Tartu Downtown Cultural Centre Architecture Competition

JURY
FINAL
PROTOCOL

30.06.2023

TARTE TATIN
Südalinna kultuurikeskuse arhitektuurivõistlus
2 / 11

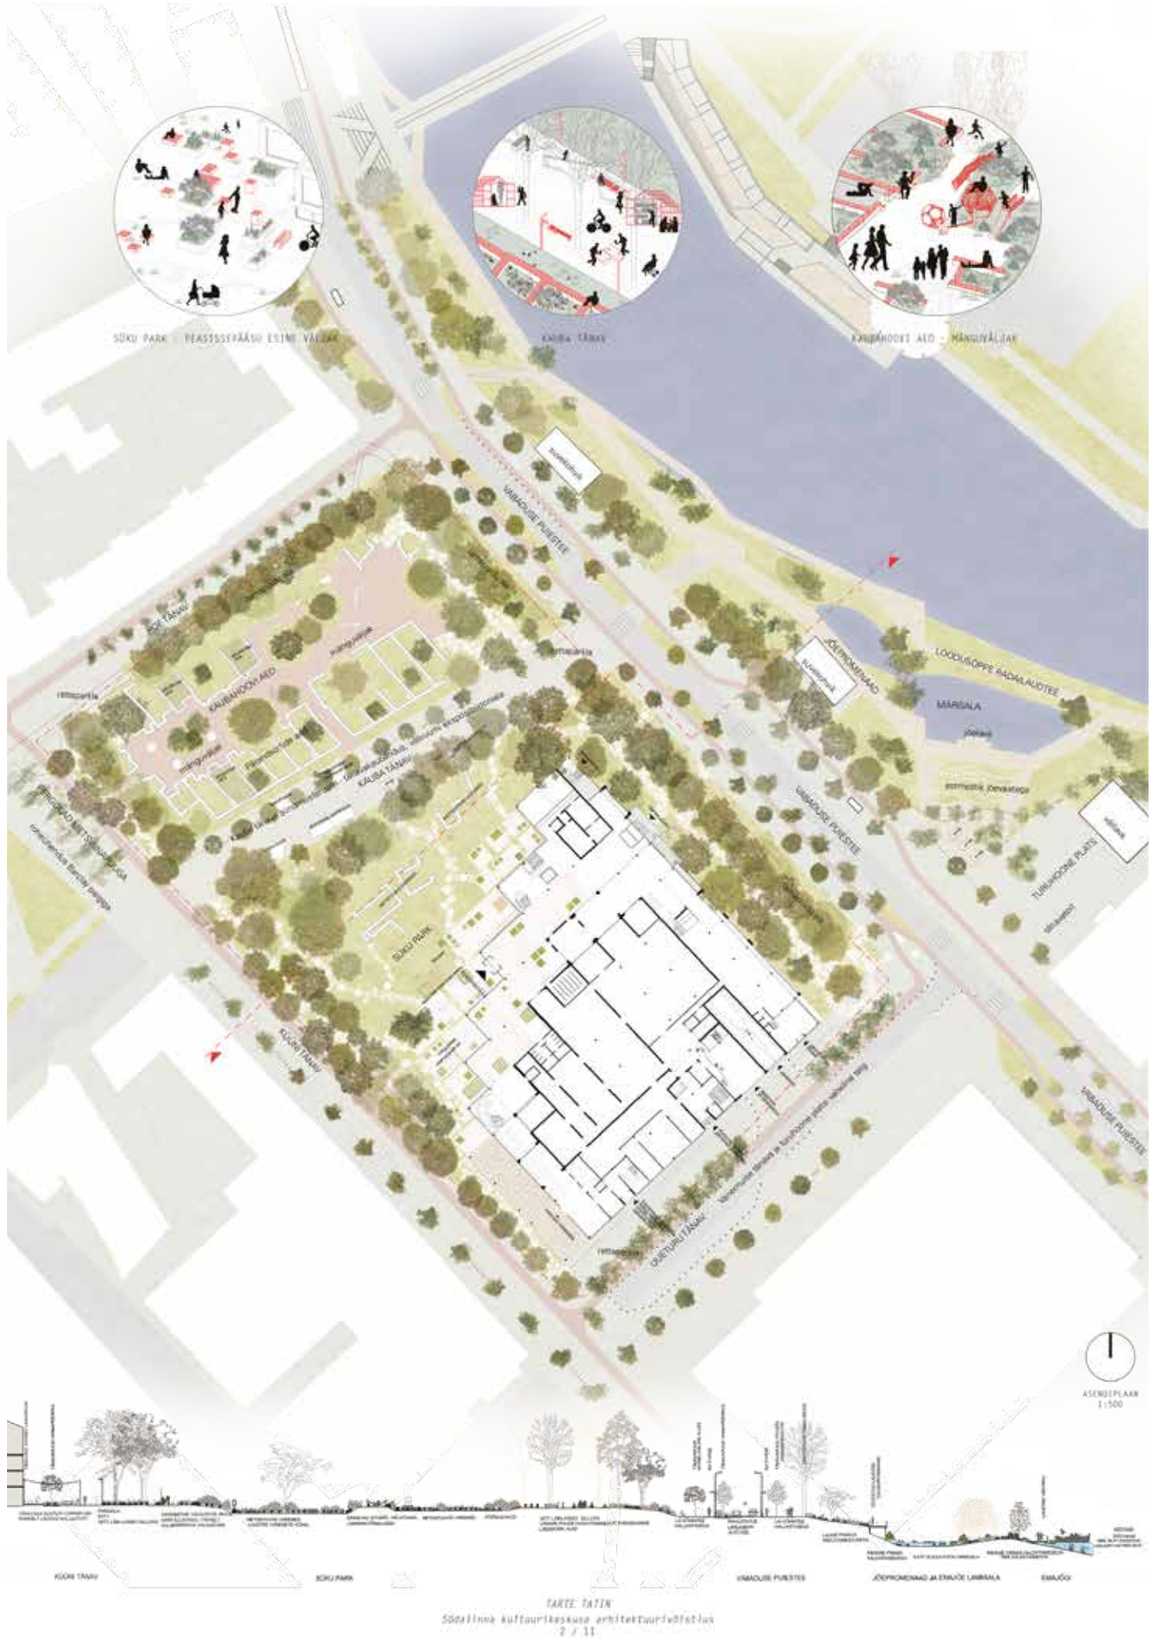
The competition entry “TARTE TATIN” stands out from other works due to its clear and well-developed modular architectural style. Rhythmizing the building as modules creates diverse facades and articulates the large volume of the building in the urban space. The cantilevered building front facing the park has an attractive and inviting effect, bringing the large volume of the building to a human scale. The suitable long lobby area zones well the different user groups of the building, while logistically connecting different parts of the building. Functionally, the building is very well structured. An exciting concept is to emphasise the historic walls as part of the landscape architecture of the park. One of the best competition entries from the art museum perspective , while the library is only on one side of the building and opens only on the upper level. Also, the library is quite generally arranged, it is not clear whether everything will definitely fit. The loading area is well designed and the warehouses are located on the same level as the halls.

+ The exciting modular architectural language and articulated facade make the large building volume more human-sized.
+ The cantilevered building front on the park side has an attractive and inviting effect.
+ Diverse and interesting outdoor space. The concept of the area along the Emajõgi River has been well developed.
+ The well-suited long lobby area zones well the different user groups of the building, while acting as a connecting space.
+ The warehouses of the halls are located on the same level as the halls. The warehouse of the great hall is located in the immediate vicinity of the stage. Backstage is located near the stages and is on the same level as the stages.
+ The roof is walkable and landscaped, and a separate sitting area is designed in the recess.
+ Logistics inside the building and orientation in the building are well thought out.

– Due to the lobby of the building, the building does not have a clear main entrance and centre, which would help make the building more visible and inviting in the urban space. Also, the entrances are located in the middle of the park area, too far from the adjacent streets, which makes it difficult for people to reach the building naturally.
– Throughout the entire library, only classic reader workplaces (chair+table) in various configurations are planned. It is not possible to understand what the library concept is in the project. A more detailed division of departments and rooms is missing.
– The height of the building +18 m exceeds the permitted height on the side of Küüni Street by 1 m, but it is possible to lower the solution by 1 m on this side, as the building has characteristic height steps.
– Under the protruding parts of the building, it is not possible to achieve completely natural conditions (precipitation, light regime) and therefore it is doubtful how easy it is to green them in the usual way.

– Although the area of Keskpark to be preserved is large and, thanks to the reconstruction of Vabaduse street, it is much better landscaped than the current one with green areas along the river, the effect achieved is significantly reduced by the large and presumably paved playground.
– Accessibility solutions have not been thought through in sufficient detail, there are many solutions with stairs in the outdoor space, which makes moving with a wheelchair difficult. The cobblestone pavement of Kauba street is not suitable for people with mobility aids and is also uncomfortable for other people.
– The gross height of the upper floors is 4 m, i.e. the net height of the room is approx. 3.00–3.30 m including ventilation and acoustic ceiling. The height of the room remains a little too low.

Ristlõige A-A
1:250

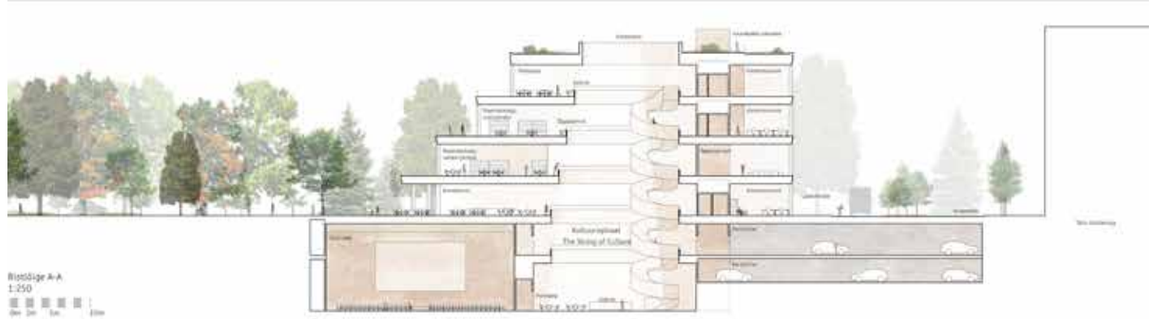
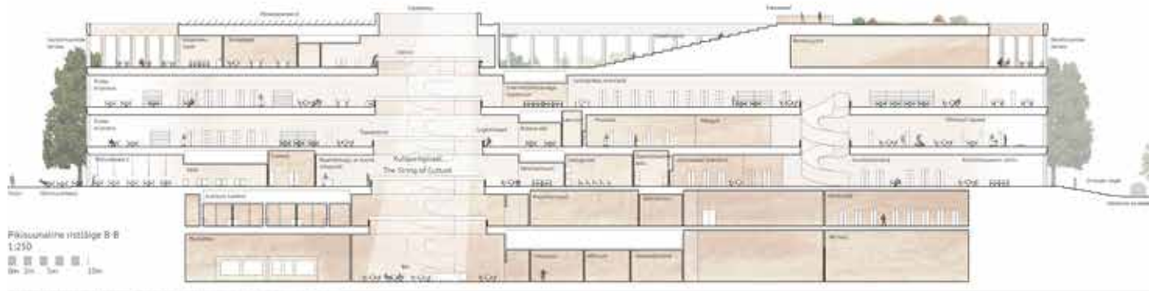
The competition entry “ROHELINE KULTUURIKESKUS” stands out from the others with its thoroughly worked out park area solution and detailed design. The architectural volume of the building does not have a dominant effect on the urban space and is solved with very exciting curved steps, which makes the spatial impact of the building volume smaller. The clear placement of the building on the side of the department store leaves a large open park area free, which increases the richness of life and creates a very strong connection between Barclay park and the riverside green space. An interesting solution is also to move the front of the building on the river side to the historical building line and thus greatly reduce the spatial impact of the car driveway on Vabaduse street. The interior of the building is well organised around a central sculptural staircase. The main drawback is the lack of a structural solution for the building and the excessive compression of the event centre and museum areas. In the building, the necessary logistics surface has been sacrificed to achieve volumetric airiness in the urban space, which makes solving internal logistics difficult. The logistics of the basement and loading areas is very incomplete and changing it can significantly change the building solution and the exterior design.

+ A very thoroughly developed concept of the park area and biodiversity.
+ The small ground volume of the building allows a large part of the park area to be preserved.
+ The grass area is minimal and in logical places. The paths through the park are of a reasonable width and are designed as cascades of so-called pocket parks, maximising people’s contact with the greenery rich in life.
+ A large part of the roof is a green roof, while also being accessible to people for green experiences.
± The central sculptural staircase in the interior is an attractive solution, but as the main axis of movement it seems awkward and would need a bigger gathering space around it.
– The building is intended for a library and the synergy with the museum and an event centre has not gotten enough attention
– In the building, the necessary surface has been sacrificed to achieve spatial airiness, which makes it difficult to solve internal logistics.

– Access to the art museum and event spaces by service trucks remains unresolved. Exhibition halls and storage rooms are connected by narrow corridors. In the basement (-1st and -2nd floors) the location of a large freight elevator is shown, but there is no access to them.
– All basement logistics and planning should be played around to a significant extent to ensure functional performance, achieving this without breaking the integrity of the design is doubtful.
– Moving from the warehouse in the small hall along the narrow corridor. The doors of the hall and the warehouse are not in the same place in the small hall, which makes it difficult to move things to the stage. The halls are very close to each other, which requires very high acoustic isolation.
– The constructive solution of the building is not sufficiently described, the structural part has questionable solutions. Since the load bearing structure impacts the space divisions in a significant manner, the additional structures might change the architectural design in a significant way.

– The exterior design of the building uses a lot of wood, including facade boards and solar panels, which are not protected from the weather. It leads to high maintenance and routine repair costs.
– The building on the Küüni street side seems somewhat taller than allowed, but it can be brought into line with the conditions, because there is a roof terrace on the Küüni street side, which is surrounded by the continuing roofless part of the facade, which can be built lower if necessary or omitted.
– The destination of Vanemuise street does not extend to the river, and there is no clear urban square area in the lush park. Few functional places for activities in the park space. The riverfront has been left intact from the overall concept and designed as a concrete paved promenade as it is today.

Asendiplaan 1:500
aed
2/10

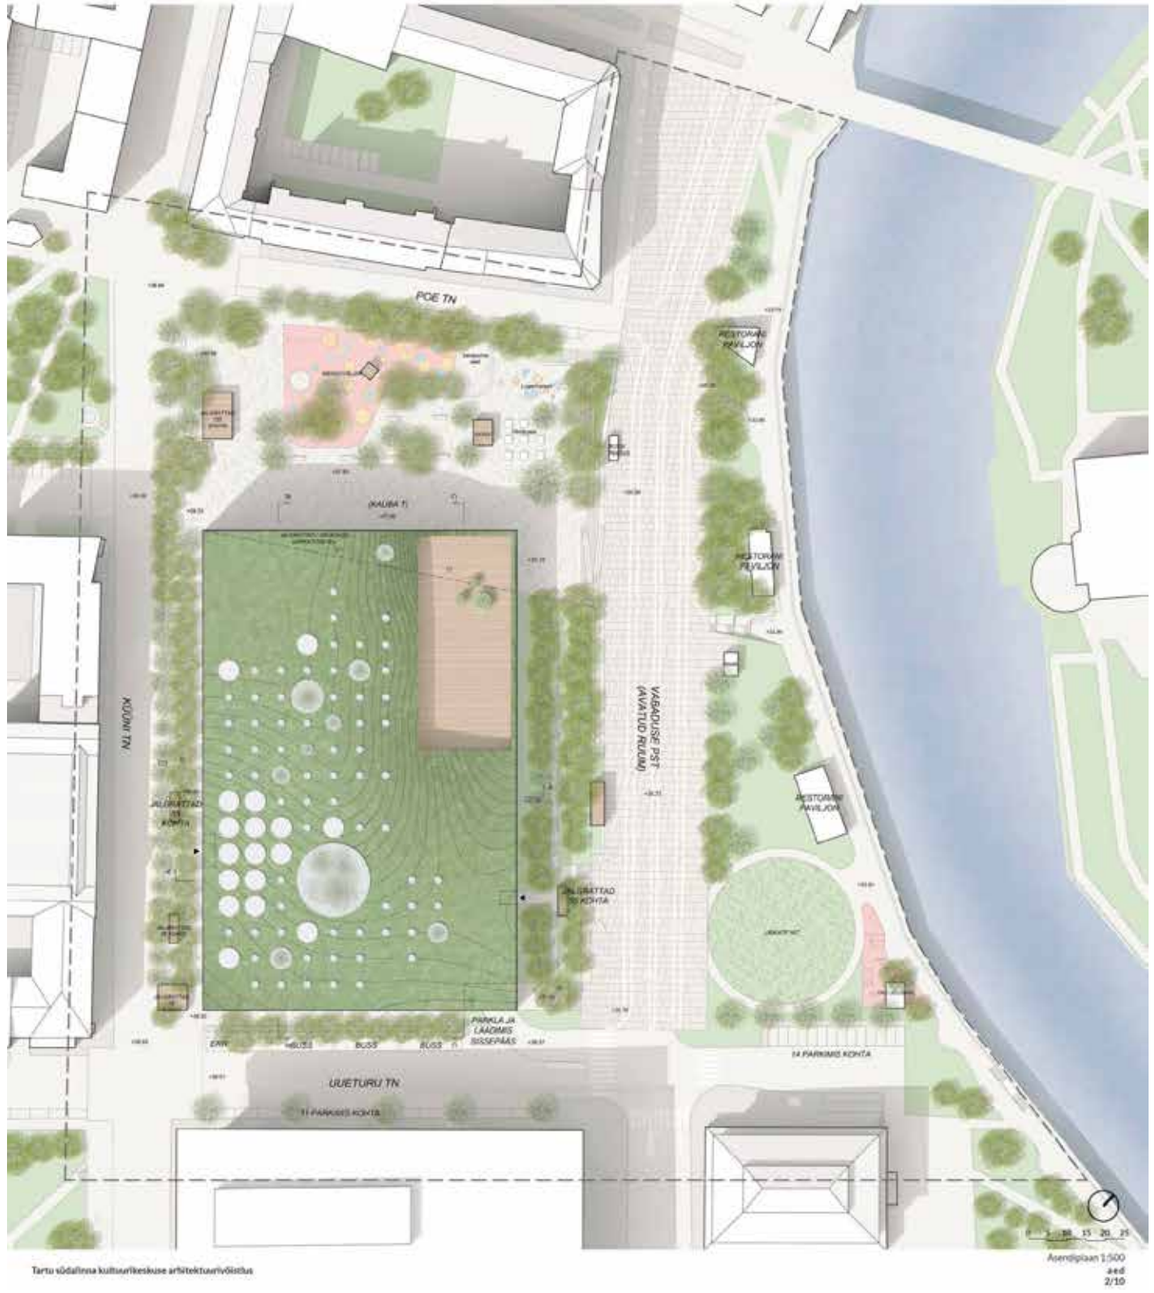
The competition entry “AED” is a professional work, the concept of which is very clear and urban spatial decisions are well perceived. The strength of the project is the interior, which is very elegantly designed. The library reading areas have space and spaciousness as most functions are on one level. The general layout and logistics of the rooms are clear. The open floor is also very inviting to the outside, while the solution of the urban space around the building has remained superficial and does not form an understandable whole, and the rethinking of Vabaduse street and the riverside has not been done.

+ The interior is elegant, the spatial solution of the library is strong and well thought out.
+ In-house logistics are good.
+ The entrance to the building and the playground area on the Poe street side is a good and attractive solution.
+ Entrance to the parking lot has a minimal impact on urban space.
+ The loading area is of sufficient size and can serve several large cars at the same time.

– The public space is too monotonous. Uueturu street is an empty stone field, pedestrian traffic is unresolved.
– The park area is small, the building dominates the natural environment. Attempts have been made to preserve the large park trees, but the trees are located too close to the building and will be damaged in any case.
– The greening of the roof is monotonous. Roof greening promotes biodiversity, but it does not allow city dwellers to enjoy green life, as it is inaccessible to people.
– The street space and the riverside of Vabaduse street have not been dealt with.
– The chosen architectural language is not convincing, it is rather decorative, and in the given location it has the effect of amplifying the size of the building volume, not softening it.
– The museum is not located on the same floor as the library, there could be a better logistical connection to create synergy.
– The auxiliary rooms of the halls are not very well thought out, and moving the decorations into the small hall is difficult through small doors and a narrow corridor.

– Large trucks have been moved to the basement floor, which is a complex and financially costly decision. The height of the cars is 4.8 m. The size of the loading area has turned out to be an unreasonably large area, i.e. 1045 m^2.
– There are large openings on the second floor and the load-bearing post system is not shown in the drawings. The explanatory letter refers to the sets of glulam posts to be added. The so-called “bridge” solution, which makes the cost of the building unreasonably high, adds 20% to 30% to the construction cost.
– There are no technical room(s) in the building, including ventilation equipment on the 1st or 2nd floor.

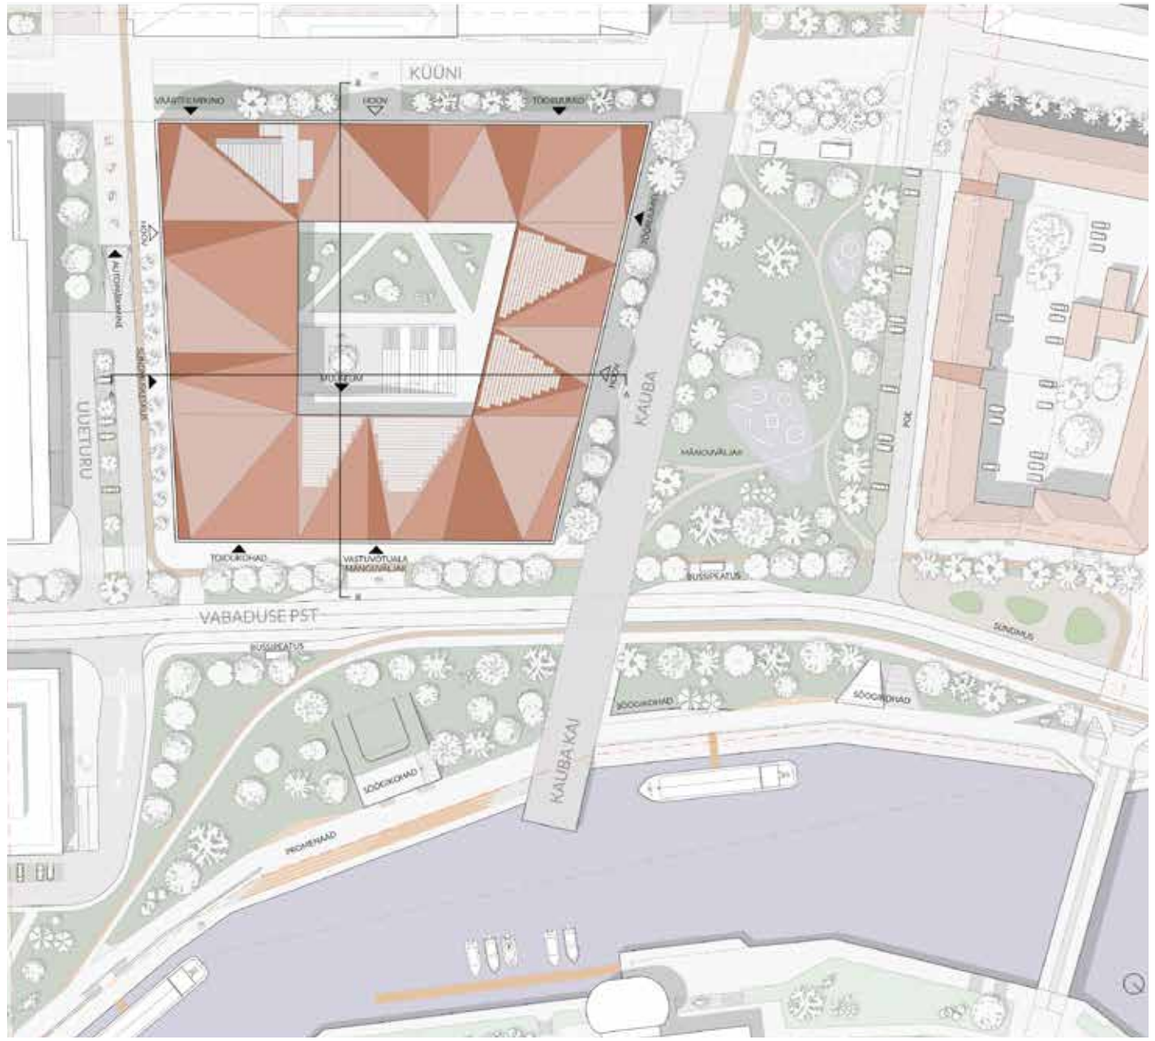
“PUIDUST SILUETT” is very clear in its architectural concept and stands out from other works with its strong idea of a roof landscape silhouette. The visuals of the building are high level and the architectural language of the silhouette are very elegant and enjoyable. The historic building silhouette done with the roof structure is interesting, but the courtyard makes the building visually massive. The courtyard helps to bring natural light to most of the rooms, but it makes the internal walkways quite long. Placing the library on one level is positive, which makes the use of the space comfortable and flexible. Küüni street and the area along the Emajõgi river are connected by a clear pedestrian axis, and the stepped area along the Emajõgi river is well thought out. Parking and logistics are well thought out. At the same time, the courtyard does not create a very clear added value and only reduces the integrity of the large park area and makes the building very dominant over the surrounding environment.

+ The architectural concept is clear and distinct. The motif of the silhouette is elegant and finely drawn.
+ Biodiversity is generally discussed in the project description. A lot of existing trees are preserved. It is planned to reduce the width of Vabaduse street in order to make the green corridor work. The area of the existing parking lots will also be significantly reduced.
+ Technical servicing and transport is done from the same level as the stages. Backstage, make-up rooms are located on the same level as the stages and in close proximity.
+ From the library’s point of view, being located on one level is convenient and increases accessibility, allowing for a comprehensive design of the area
– The building does not have a definite centre and the courtyard alone cannot fill it, as the outdoor space is not in active use for a large part of the year.
– The logistics of the building are not good, too long connecting roads.

– The access to the promenade from the end of Uueturu street is unresolved, Vanemuise street does not continue to the river.
– The arrangement of the furniture in the library is too rigid – shelves as separate zones and reader workstations as large areas, there is no variety, niches or separation possibilities.
– There are elevators in the immediate vicinity of the halls, which require very thorough acoustic insulation. Moving from the warehouse in a small hall through a very small door in the hall and from an impractical place in relation to the hall.
– The exterior design of the building uses a lot of glulam, including sun screens and support poles, which are not protected from the weather. It leads to high maintenance and routine repair costs.
– The interior design and construction of the building uses a lot of glulam and CLT, which makes the construction cost high.
– The building’s stone roofs are complex and sometimes have too little of a slope, and the use of roof stones causes problems.
